PROJECT TITLE  
**Domremy College Solais Project**

### STORMWATER MANAGMENT CONCEPT PLAN – CIVIL ENGINEERING

## **RE: DA2018/0076 DOMREMY COLLEGE: RESPONSE TO REQUEST FOR ADDITIONAL INFORMATION**

**RE: DOMREMY CATHOLIC COLLEGE - 121 FIRST AVENUE, FIVEDOCK (DA 2018/0076)  
LETTER OF RESPONSE TO COUNCIL**

1 SHADE STRUCTURE PLAN  
A03.53 1:100

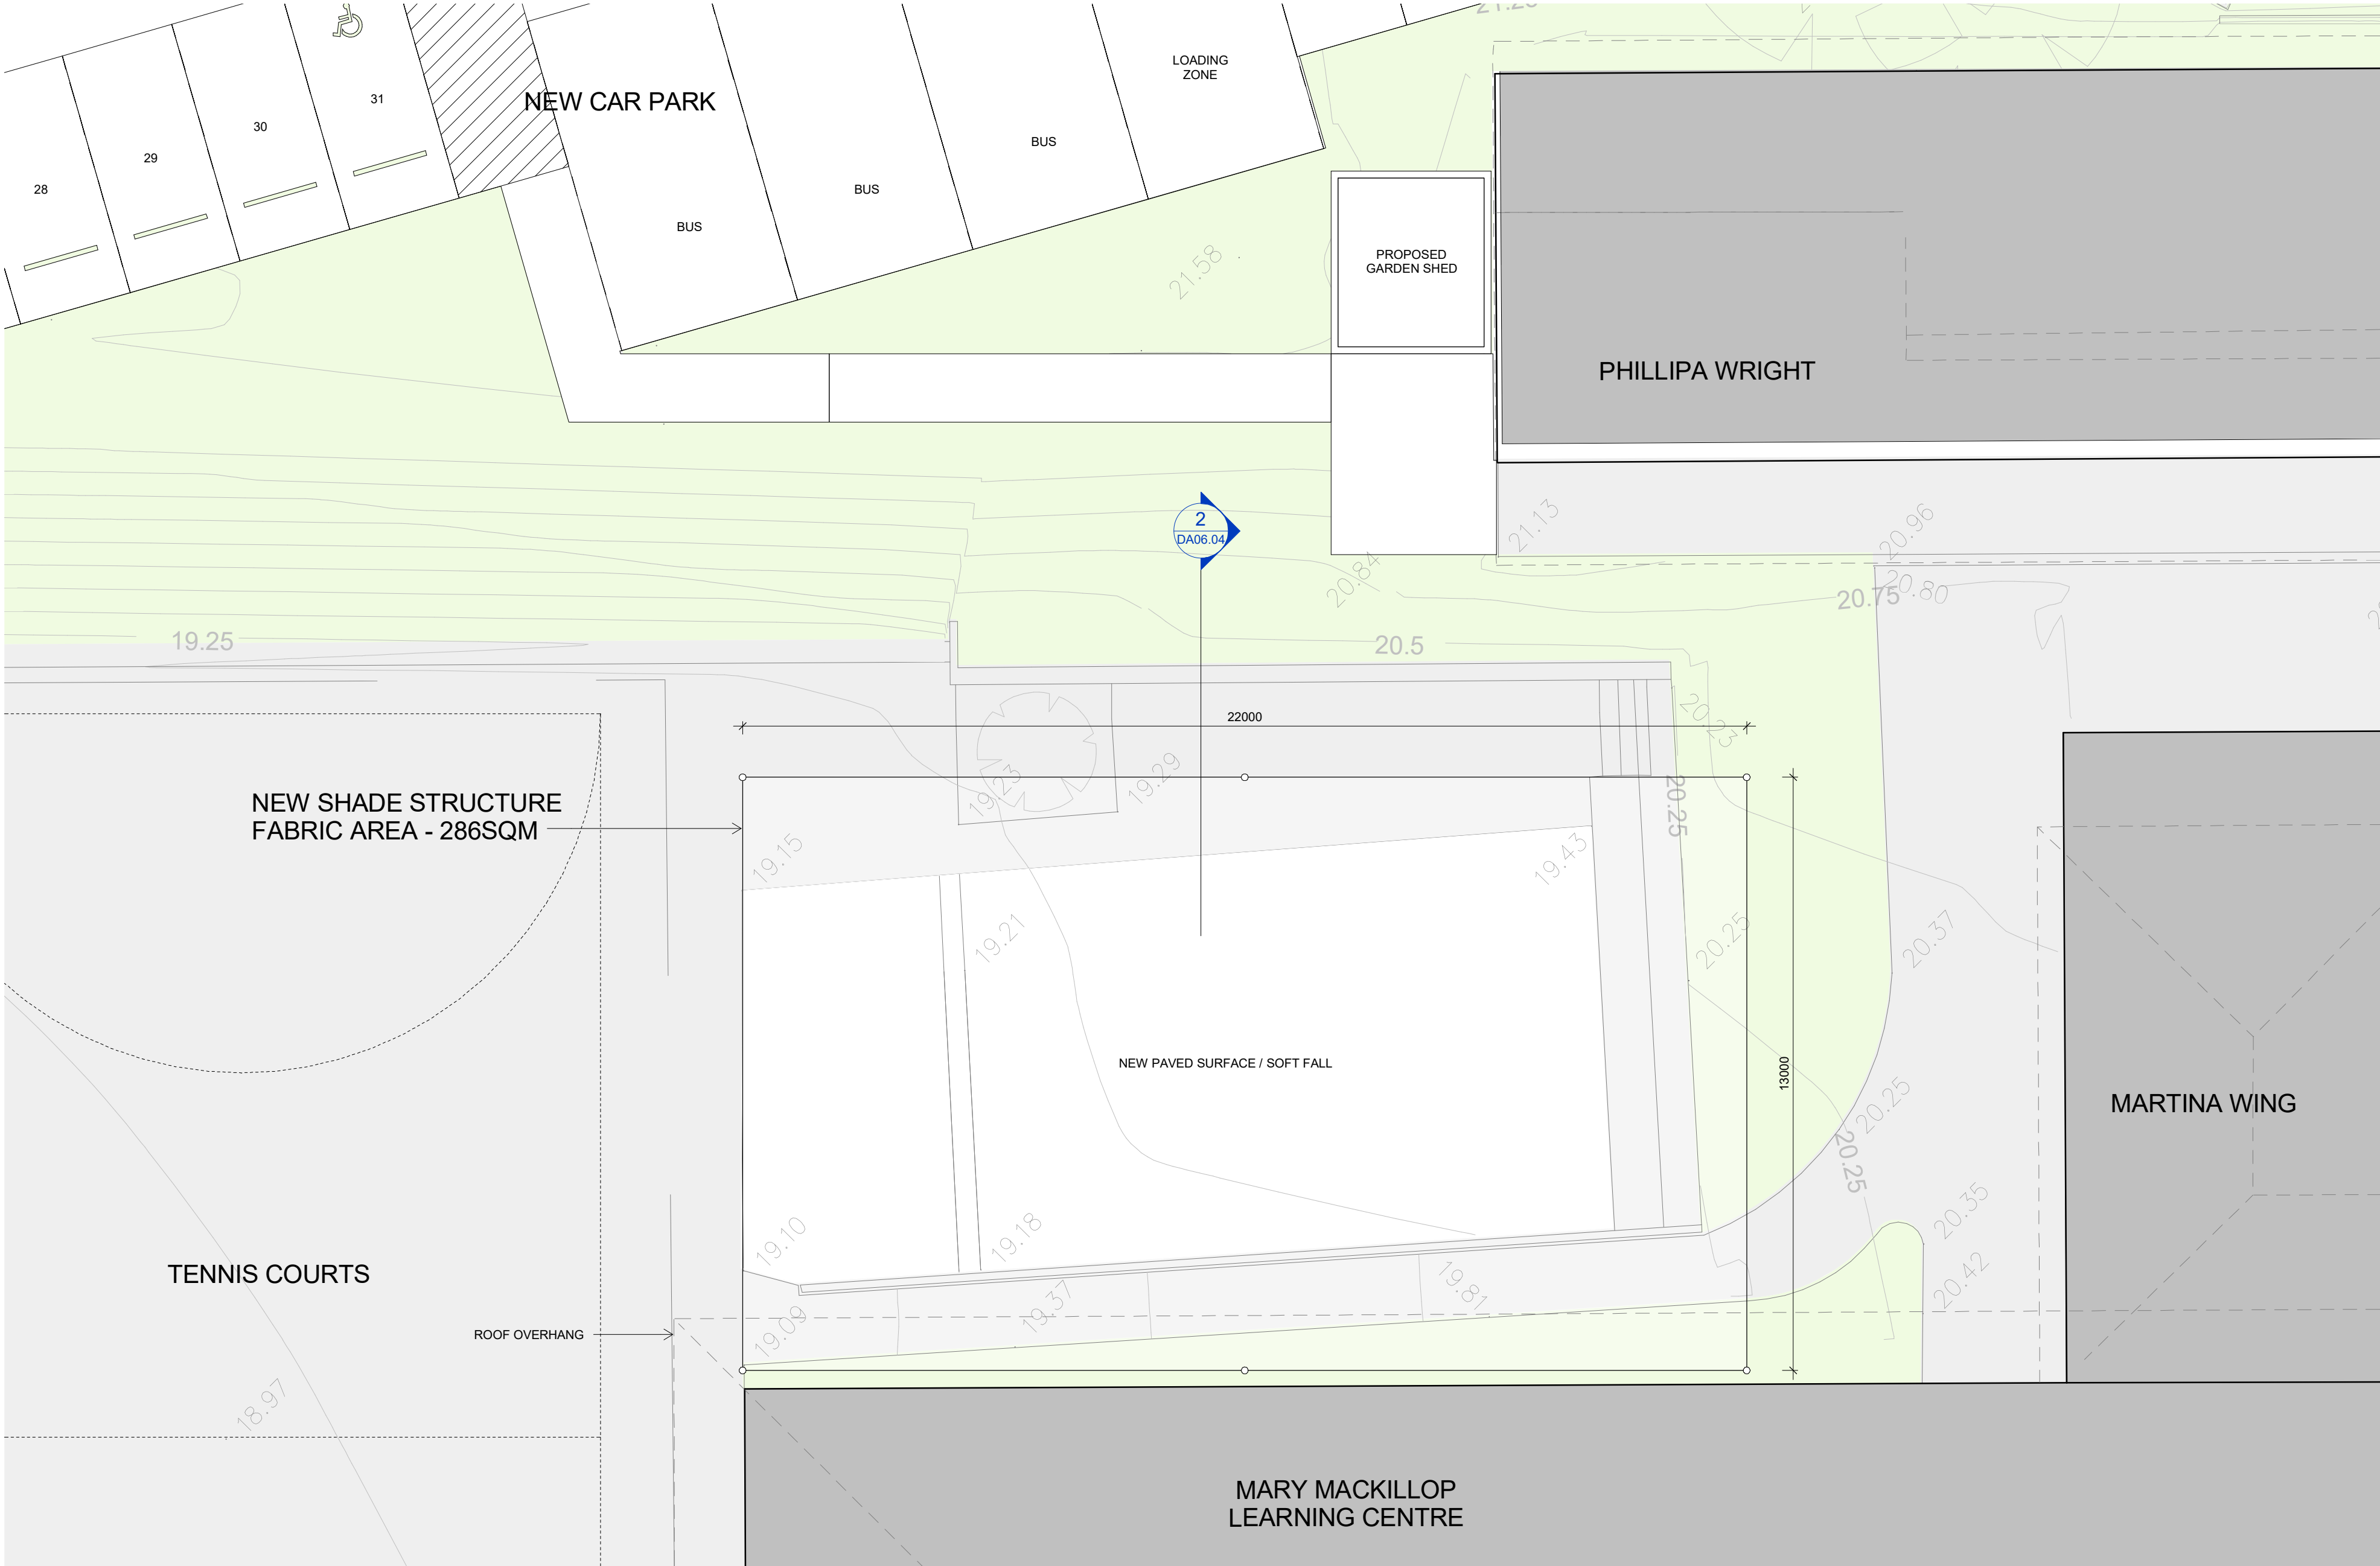
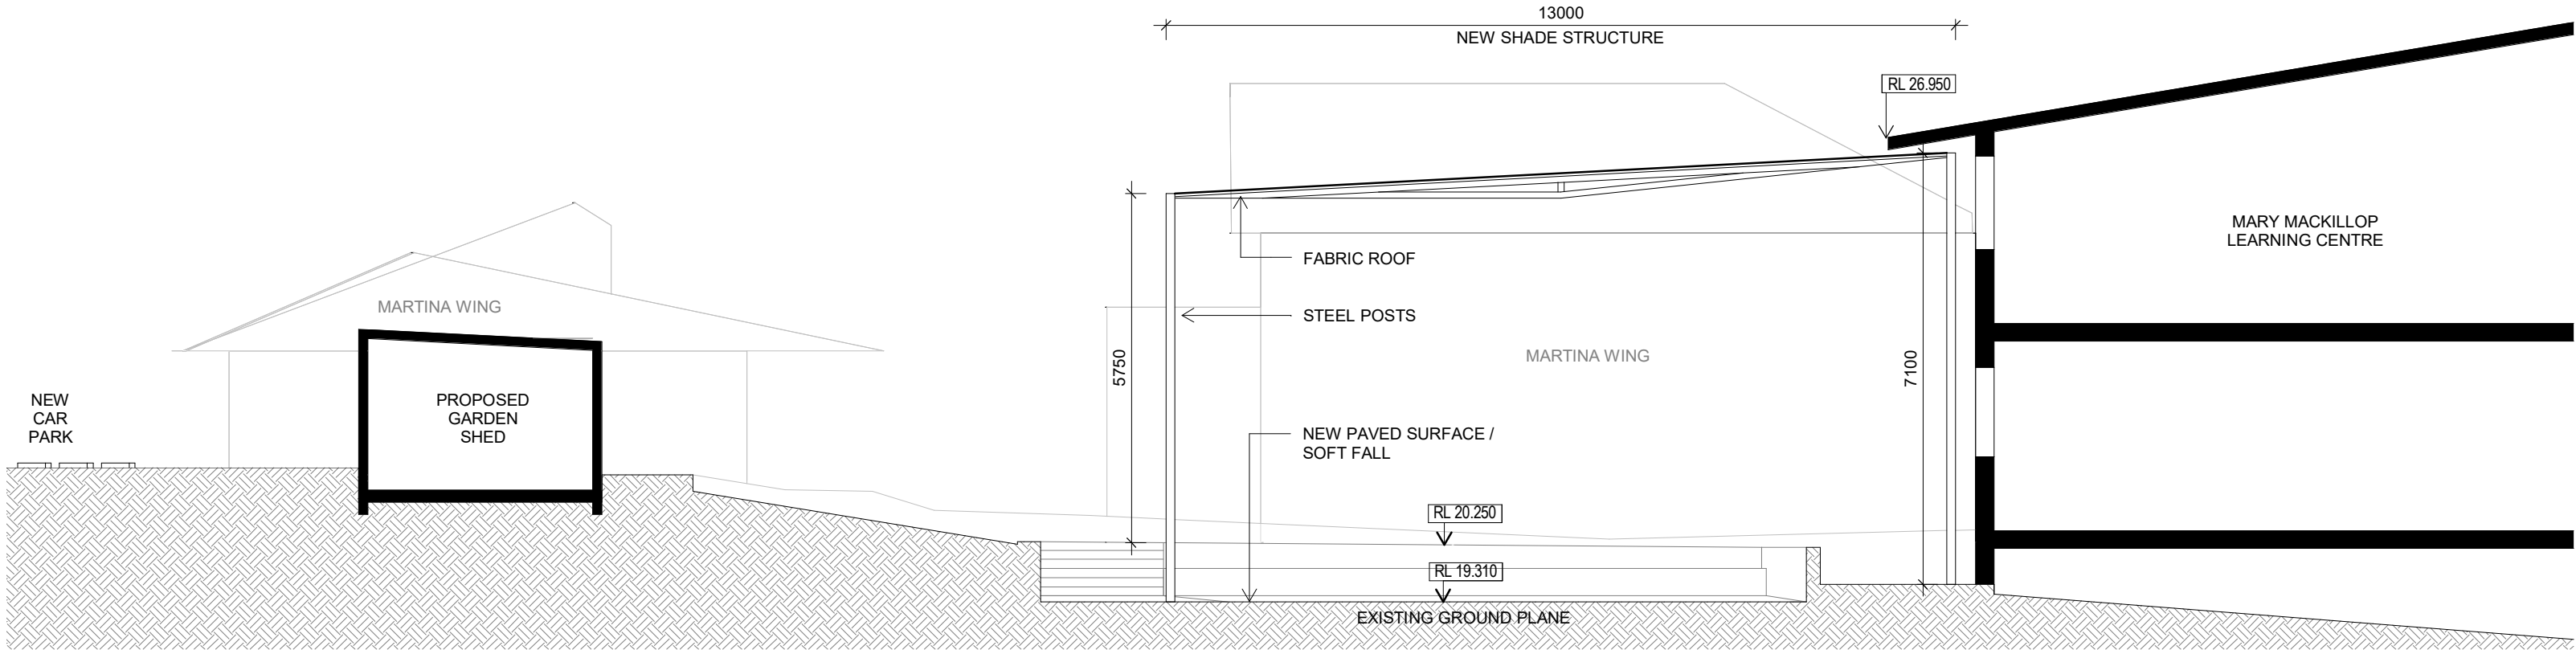
Since lodgement of the DA with Council, the Applicant has amended the proposal to include a new shade structure to the north of the Mary Mackillop Learning Centre. Pursuant to section 55(1) of the *Environmental Planning and Assessment Regulation 2000*, this letter formally requests to amend the DA to seek development consent for the construction of the shade structure.

The proposed structure will be freestanding on steel posts and measure 22m by 13m, as shown in the revised Site Plan and Shade Structure Section. The structure will have a maximum height of 7.1m to match the eaves of the neighbouring Mary Mackillop Learning Centre. The existing grassed area below the shade structure will be replaced with a new paved surface or soft-fall.

project no.  5503	drawing no.  CV-0512	rev.  02
-------------------------	----------------------------	----------------

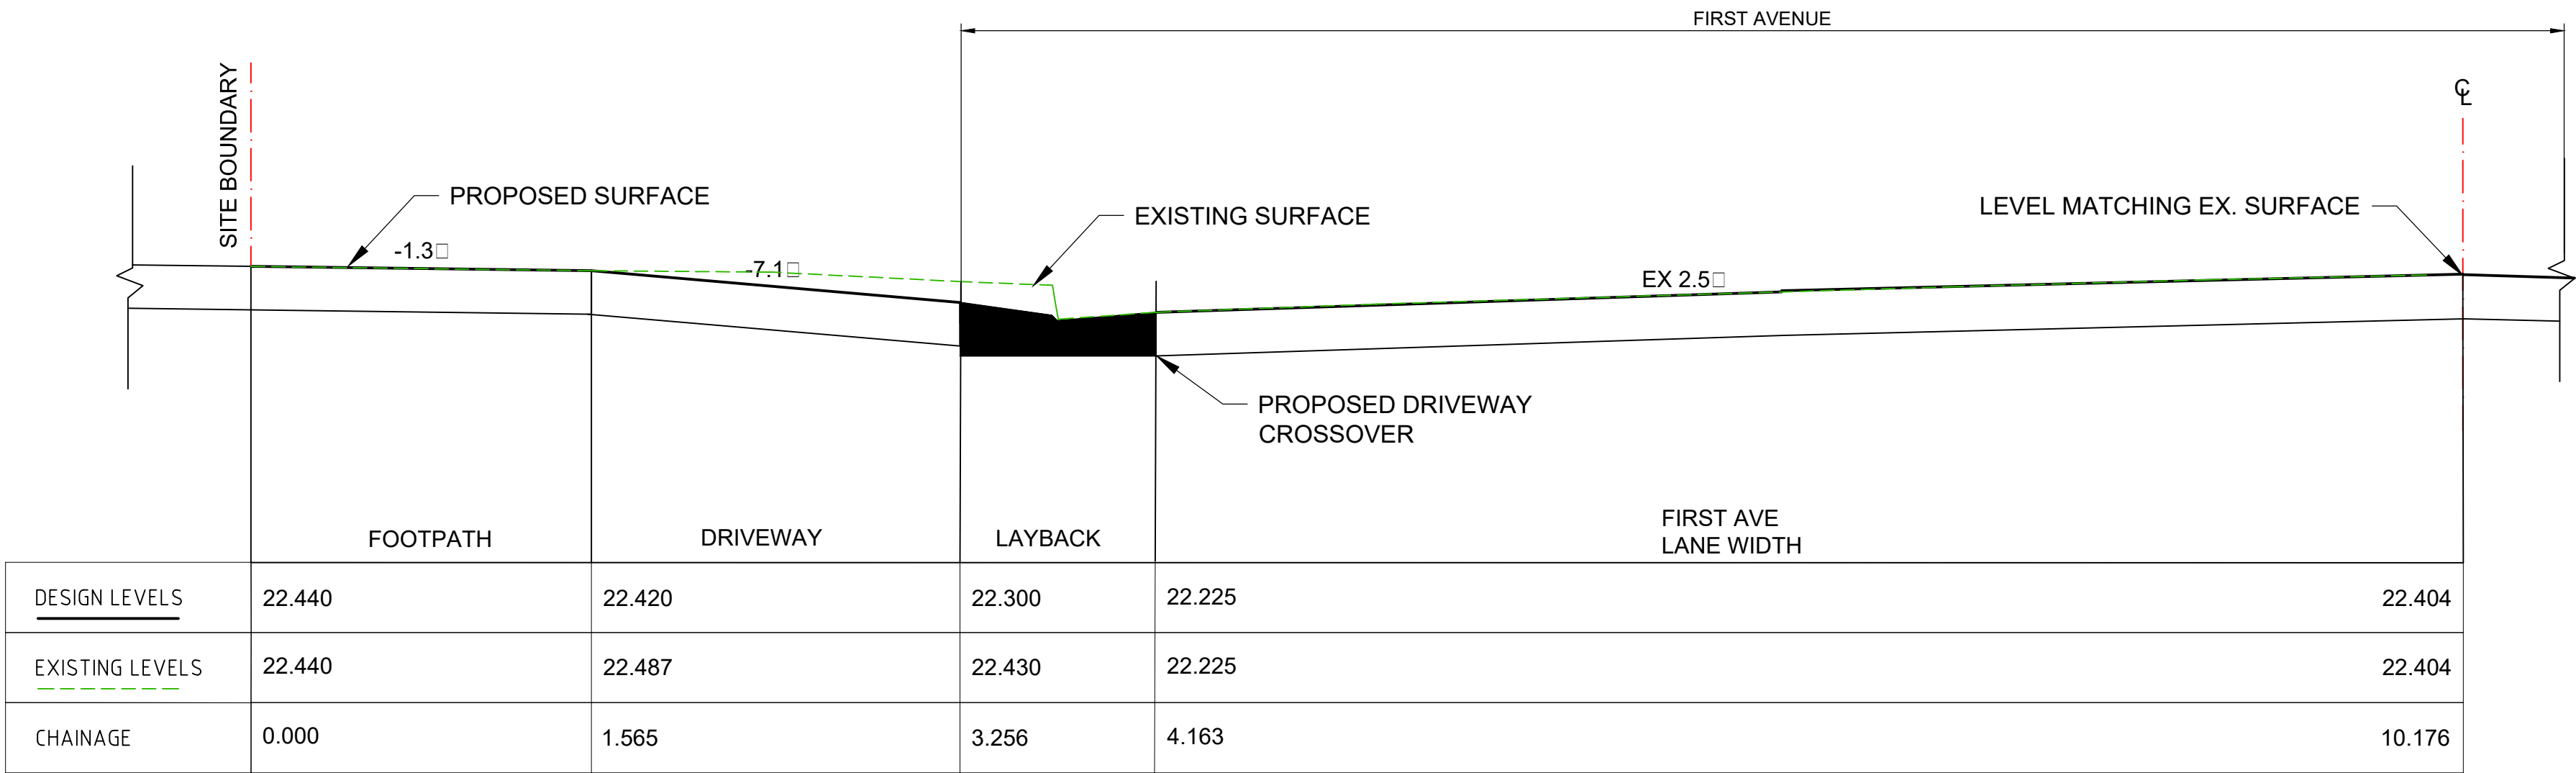
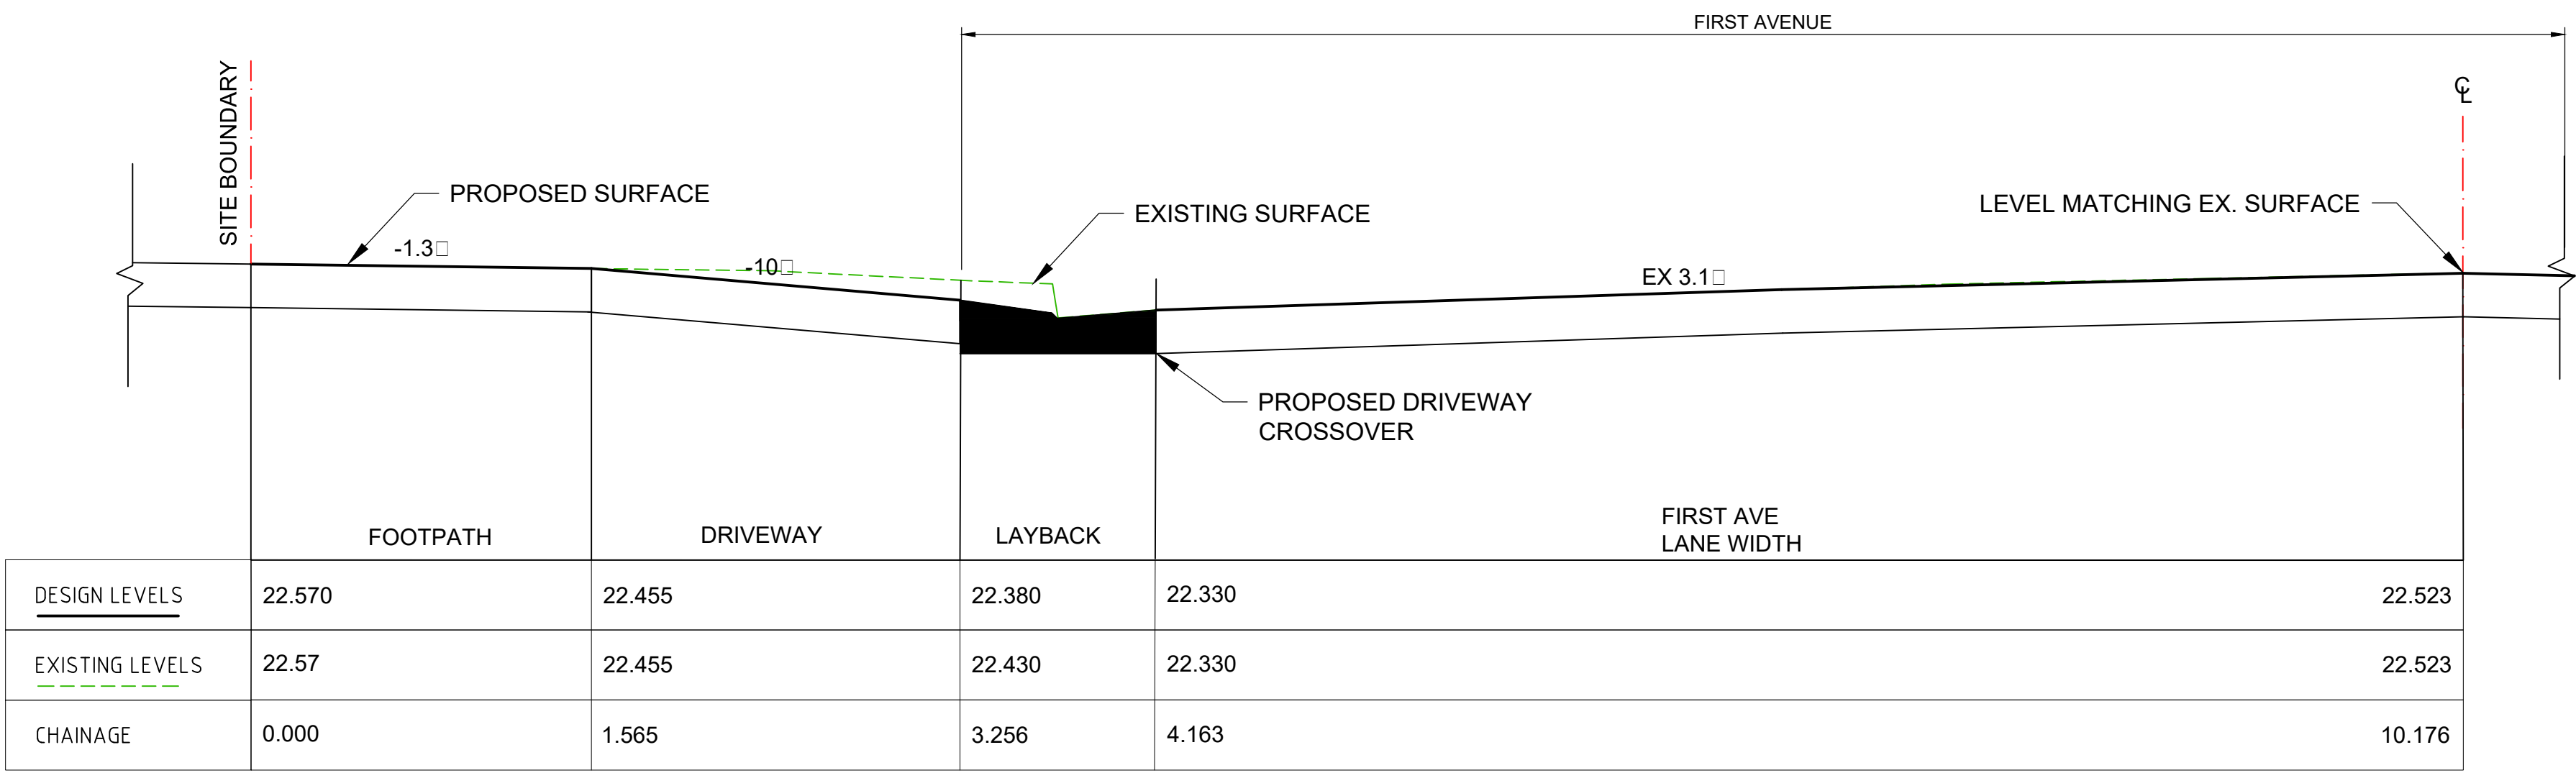
As per Council's current DCP – Appendix 2 Engineering specifications, Rainwater Re-use system with a minimum capacity of 5000 Litres shall be provided.	
Cross sectional details of required rainwater tank shall be provided.	
Should downpipes be charged to rainwater re-use tank, clean out pits/inspection eyes shall be installed and located at the lowest point of charged lines. The locations shall be clearly marked on the plan. A section through clean out pit shall be provided.	
The consultant shall demonstrate that OSD will not have "Drowned outlet". A drowned outlet occurs when the water level at the connection point "Kerb Inlet Pit" is higher than the orifice centreline level. The tail-water influences will affect the discharge rate. Therefore, Hydraulic Grade Line assessment of the proposed discharge system shall be undertaken from the existing Kerb Inlet Pit to demonstrate that the Drowned Outlet does not occur at the OSDs. If the HGL levels at the point of connection are not known, HGL can be determined from the level which is 150mm below the surface level of the discharge pit.	Refer to DWG CV-0512, SITEWORKS DETAILS SHEET 2

Driveway entrance shall be perpendicular to the kerb and gutter alignment and should not be designed with kerb returns.	Refer to DWG CV-0512 DRIVEWAY PLAN and Traffic Statement
All redundant driveways shall be removed and footway and footpath reinstated. Any redundant stormwater outlets shall also be removed.	Refer to DWG CV-0550 PAVEMENT PLAN and Traffic Statement
<b>Tree Officer and Heritage Advisor</b>	
Tree No. 38 ( <i>Phoenix Canariensis</i> ) is to be retained. As such the driveway design and layout will need to be amended to both retain this tree and ensure the ongoing longevity is not impacted by the driveway location and construction. Please amend the proposal and provide a supporting statement from both your traffic engineer and your arborist proposing suitable tree protection measures.	As outlined in the Revised Site Plan and Traffic Statement, the alignment of the First Avenue driveway and internal roadway have been reconfigured to ensure that these are clear of Tree 38 and importantly, that Tree 38 is able to be retained.
